Interactive comment on “Temperature signal in suspended sediment export from an Alpine catchment” by Anna Costa et al.

Interactive comment on Hydrol. Earth Syst. Sci. Discuss., doi:10.5194/hess-2017-2, 2017.

Fig. 1. Fig. 1: Mean annual suspended sediment concentration (SSC) and total annual volume of gravel extracted, expressed as difference from the average over the period 1989-2014

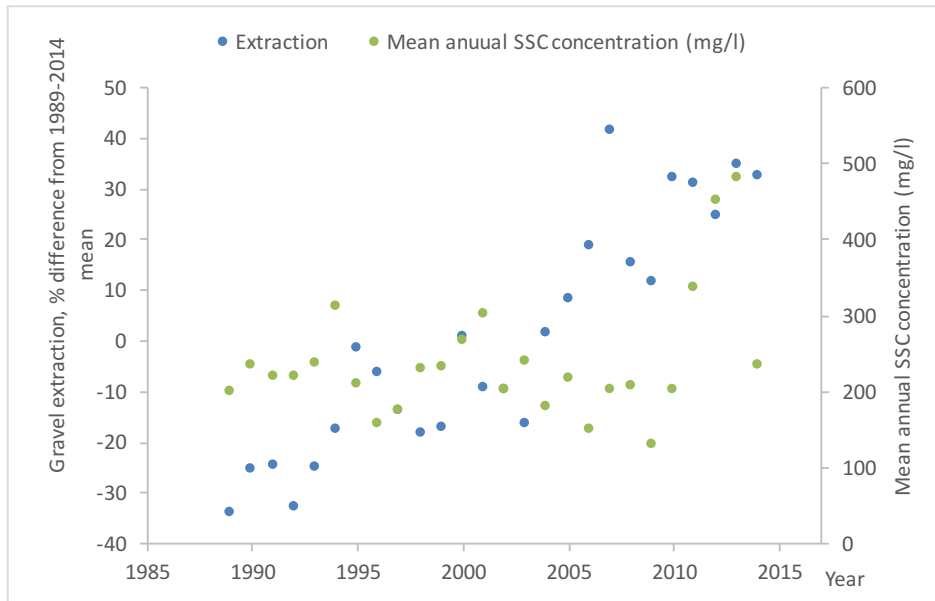
2. Lines 20-25, page 4: The discussion of anthropogenic impacts in the catchment mentions gravel mining operations along the main channel and tributaries. Such direct

disturbance of the channel could increase suspended sediment supply. Can this effect be discounted completely as a factor contributing to the observed trend in suspended sediment concentration (Fig 7c)?

We are aware that, for short periods after river bed disturbance, gravel extraction may cause local releases of fine sediments from the river bed. However, this process is unlikely to affect the suspended sediment load and balance at the outlet of the basin over seasonal and annual timescales. This is confirmed by the volume of gravel extracted along the main Rhône River and along tributaries, available from 1989. Annual volumes of gravel extracted, expressed as difference from the average over the period 1989-2014, do not show any clear correlation with mean annual suspended sediment concentration (Fig. 1). In agreement with Fig. 1, the coefficient of determination between the two variables is very low ($R^2 = 0.08$). Therefore, we conclude that, although gravel mining data for comparing the periods before and after mid-1980s are not available, gravel extraction is unlikely to play a significant role in the suspended sediment concentration rise observed in mid-1980s.
